APPLICATION FOR PERMISSION UNDER SECTION 16 OF THE TOWN PLANNING ORDINANCE (CAP. 131)

(a) Proposed use(s)/development 擬議用途/發展	Proposed Temporary Private Vehicle Park (Private Cars) (Please illustrate the details of the proposal on a layout plan) (請用平面圖說明擬議詳情)

Submission of Further Information (FI)

Further Information for Planning Application Nos. A/NE-SSH/155&156**Response-to-Comment****Comments from Drainage Services Department received on 28.3.2024**

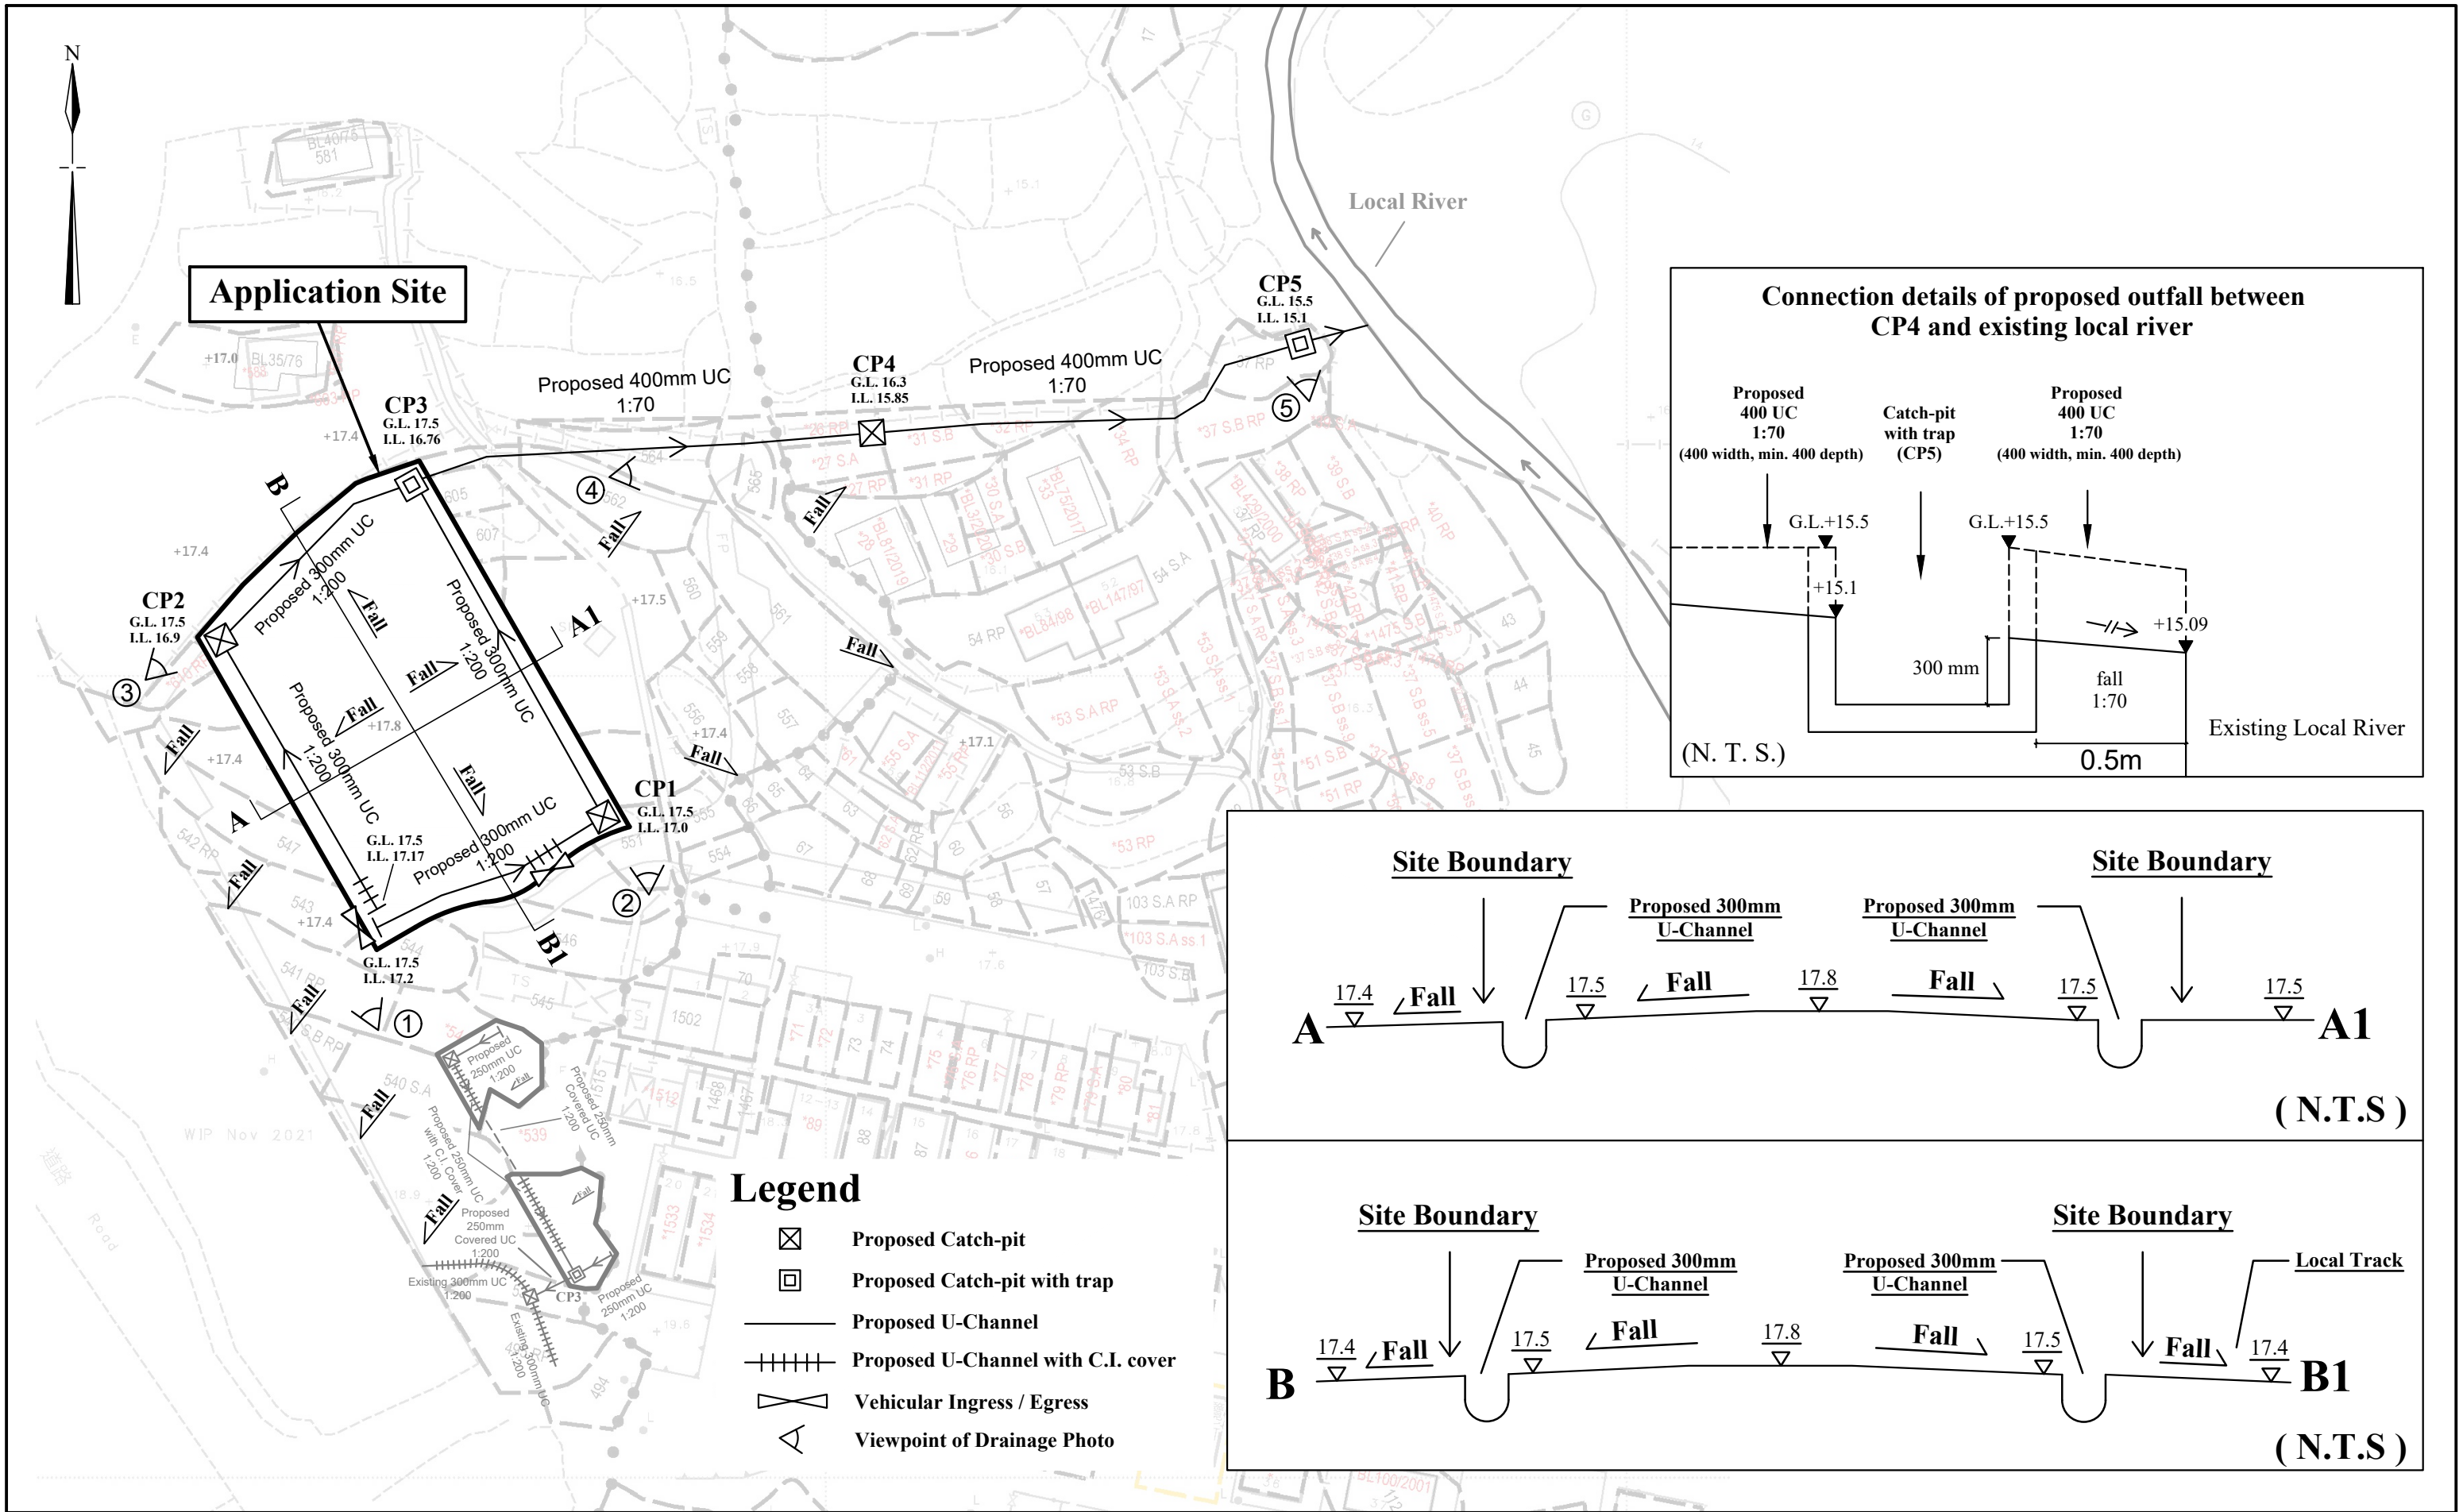
(b)	Please justify your proposed catchment area. (Please provide support evidence for all directions of the sites)	Catchment area is updated. Ground levels of surrounding area are indicated on Plan 7.2.

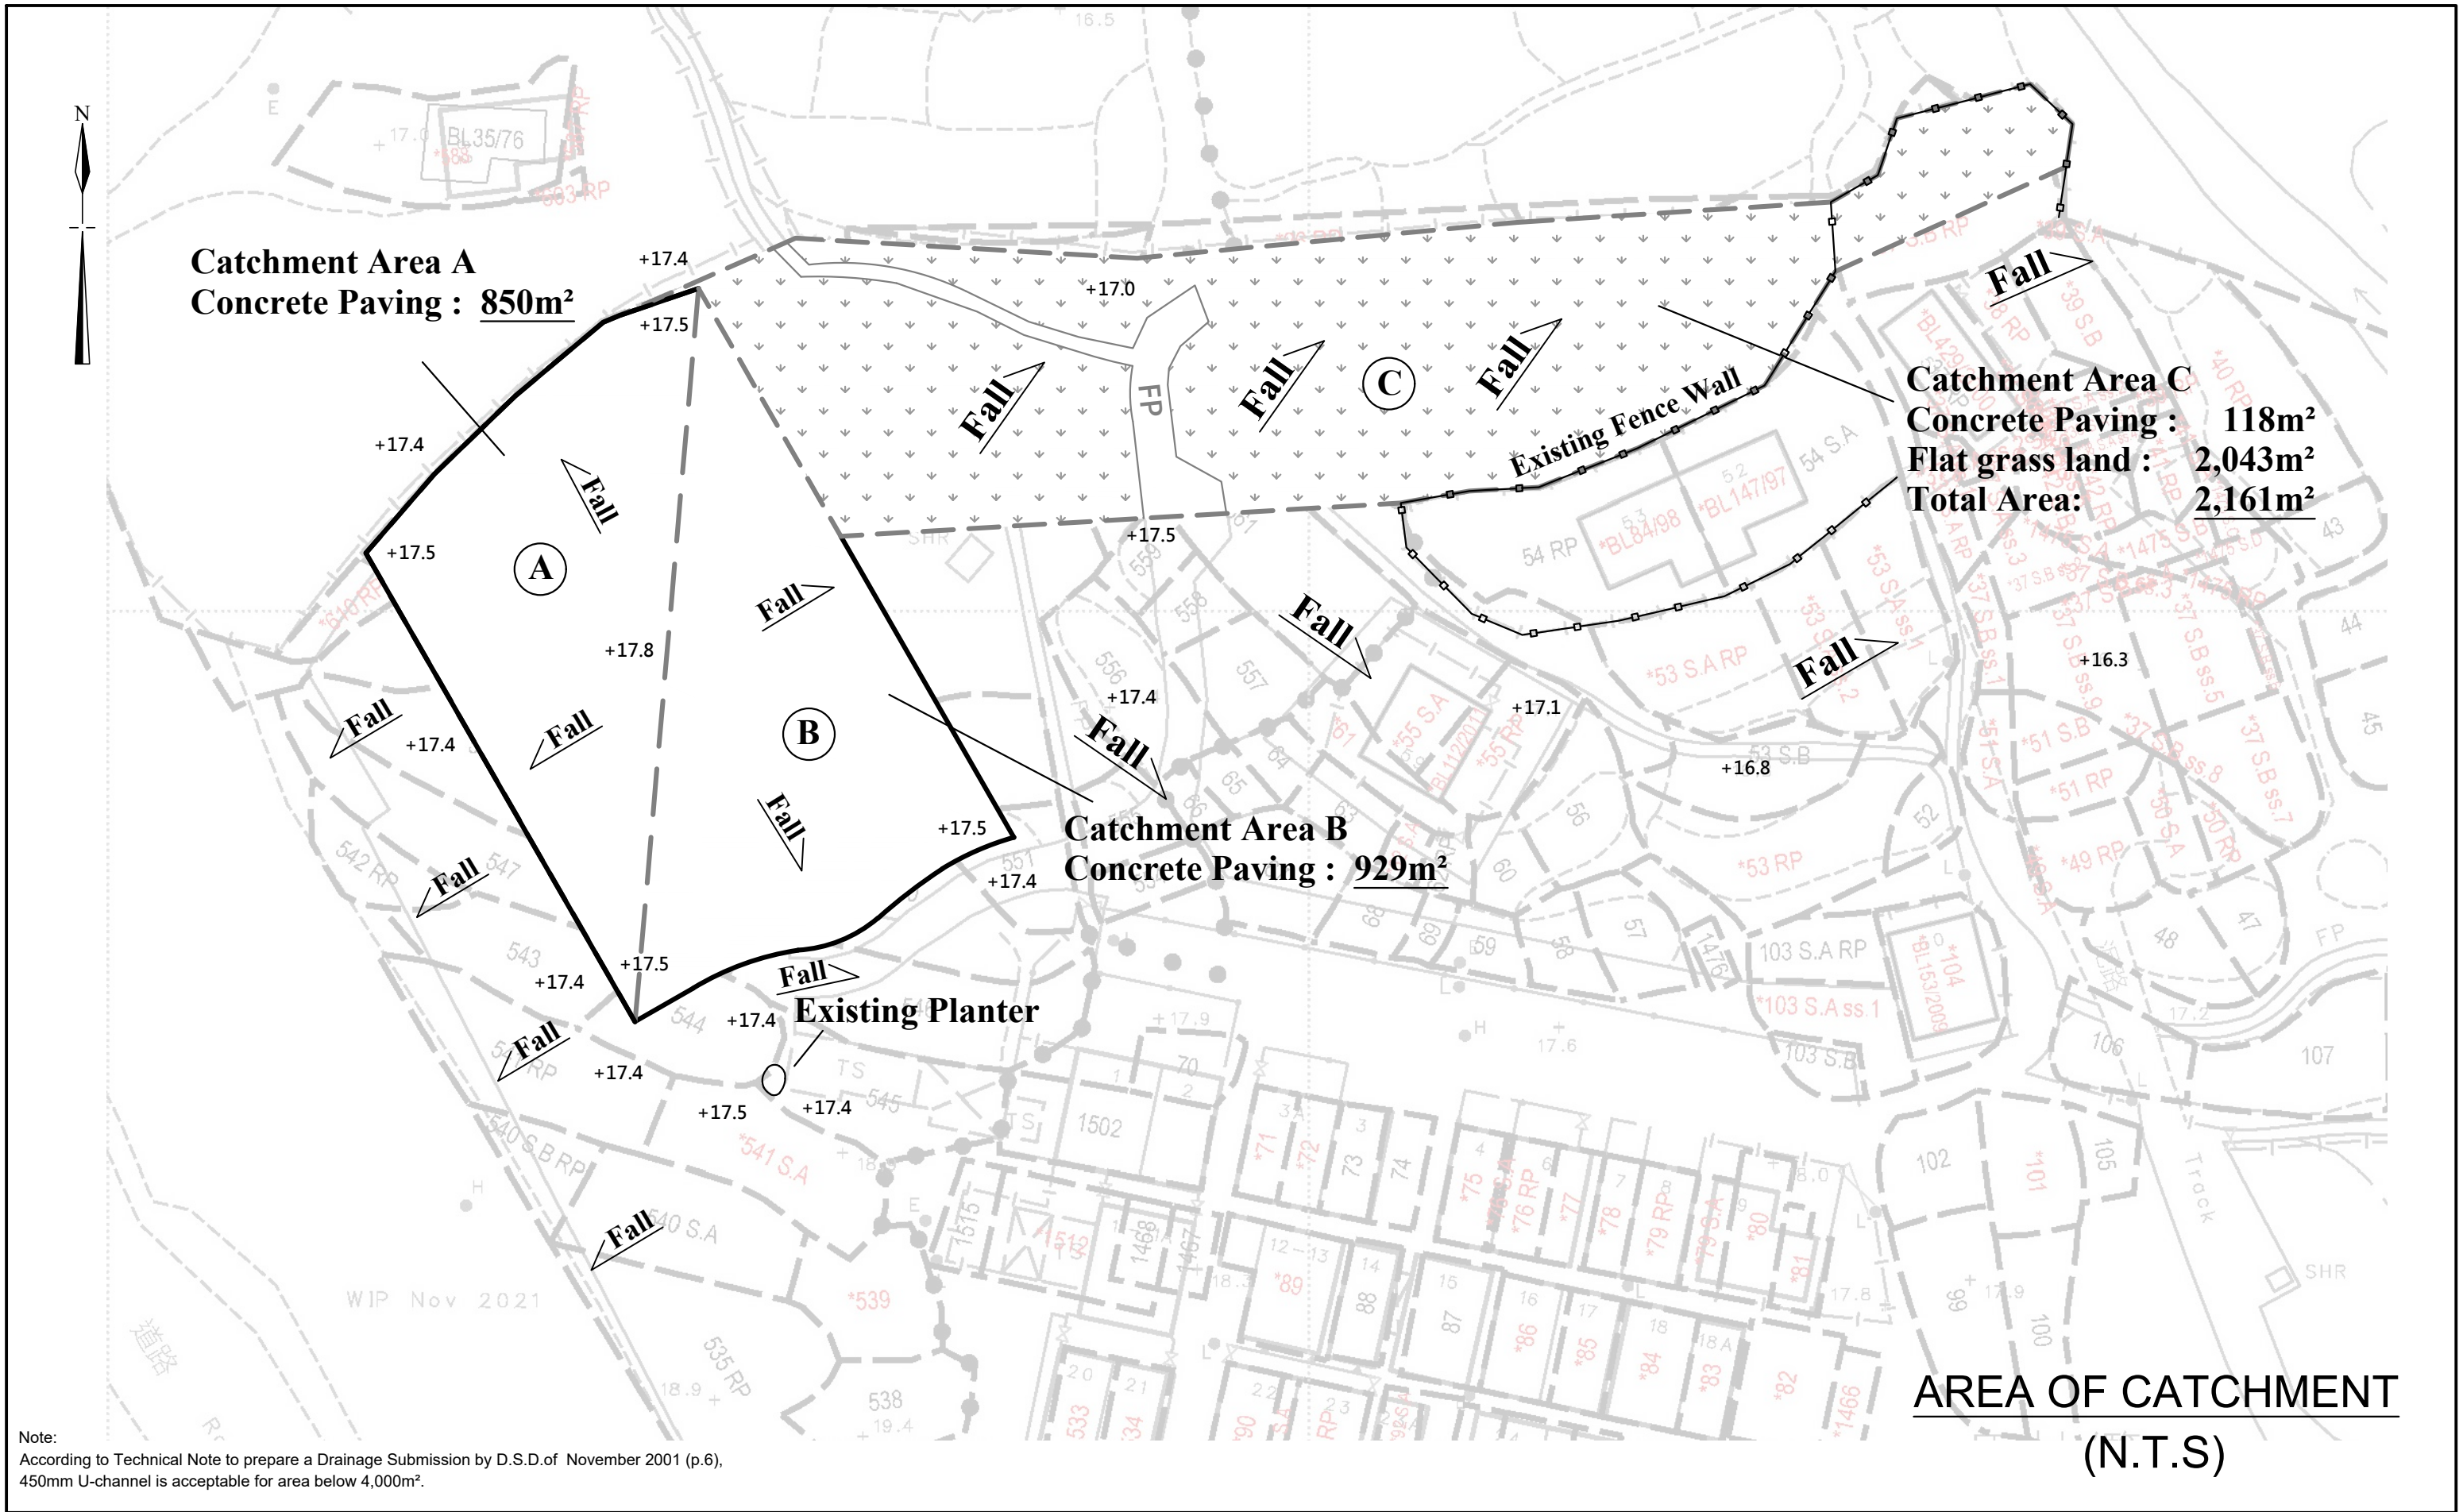
I.	Comment	Response
(c)	Please provide photos showing the existing conditions of the local river sections receiving the runoff from SSH_156.	Please refer to attached photos (viewpoint 5 and viewpoint 6) for the existing conditions of the local river sections receiving the runoff from SSH_156.
(d)	Please indicate the level of existing local river in the connection details in Plan 6.1a.	The level of existing local river in the connection details in Plan 6.1a is indicated in an updated plan (Plan 6.1b)
